**Subject:** Agenda item D, Action item: Best available technology determination for treatment of spent activated carbon at the Umatilla Chemical Agent Disposal Facility  
February 18 - 19, 2010 EQC meeting

**Subject:** Best Available Technology for Treatment of Spent Activated Carbon at the Umatilla Chemical Agent Disposal Facility

**Response to Comments**  
**Best Available Technology for treatment of spent activated carbon at the UMCDF**

Photo No.1 – Micronized activated carbon sample viewed under electron scanning microscope.  
 NOTE: Magnification scale = 2,379.  
 Horizontal scale line = 10 microns

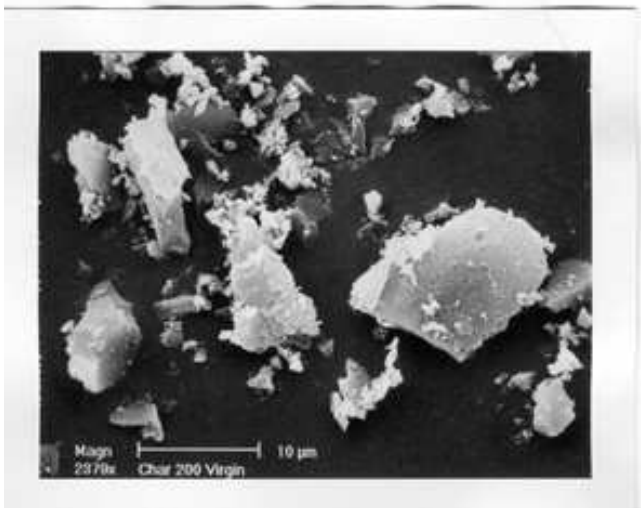
For visual particle size orientation - Photo No.1 presents an image of micronized activated carbon as viewed by the Pennsylvania State University Energy and Fuels Research Center scanning electron microscope, taken during the CMS development period. NOTE: The horizontal scale line equals 10 microns (about one-fifth the diameter of a human hair).

For comparative orientation, if five or six micronized carbon particles were lined up side-by-side, the resulting width would approximate the width of a human hair.

**Figure 1: MSI Carbon Micronization System – JACADS**

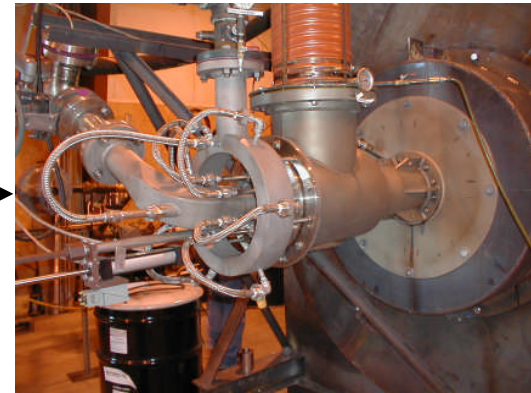
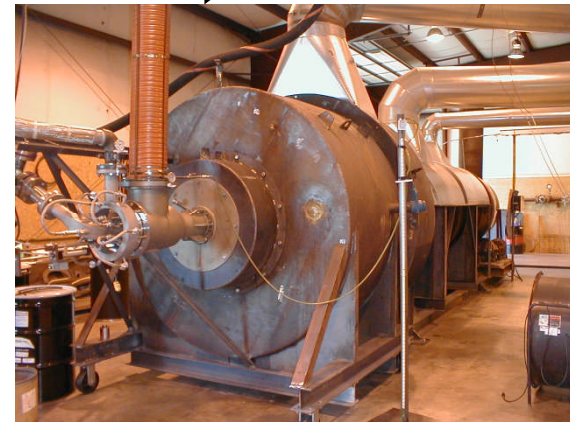
Figure 1 illustrates the basic components of the CMS as developed for JACADS.

Subsequent to the successful JACADS campaign to dispose of its agent laden carbon, MSI was asked if it would be possible to improve the CMS performance; specifically to: (a). increase throughput capacity, (b). further reduce particle size, and (c). implement modifications to minimize slagging within the burner tube.

- Increase rotational speed of micronization mill impactors.
- Add one, or more, stages to the mill.
- Increase the diameter and possibly height of the mill.
- Changes to the structural material used for the inside walls of the mill.
- Air flow diverters within mill.
- Type and number of impactors on lower stages of mill.
- Stage settings gap adjustments.
- "Fine-tuning" to the inlet feed conveyor to the mill.
- A "spreader" is the critical item at the burner tip that carbon touches just prior to entering the flame "envelope". MSI has developed alternative configurations, and identified other metal allows, that should enhance combustion efficiency and reduce slagging.
- Modification of swirl vane dimensions and angle alignment.
- Update burner tube ceramic liner (technology continually improves in this industry).
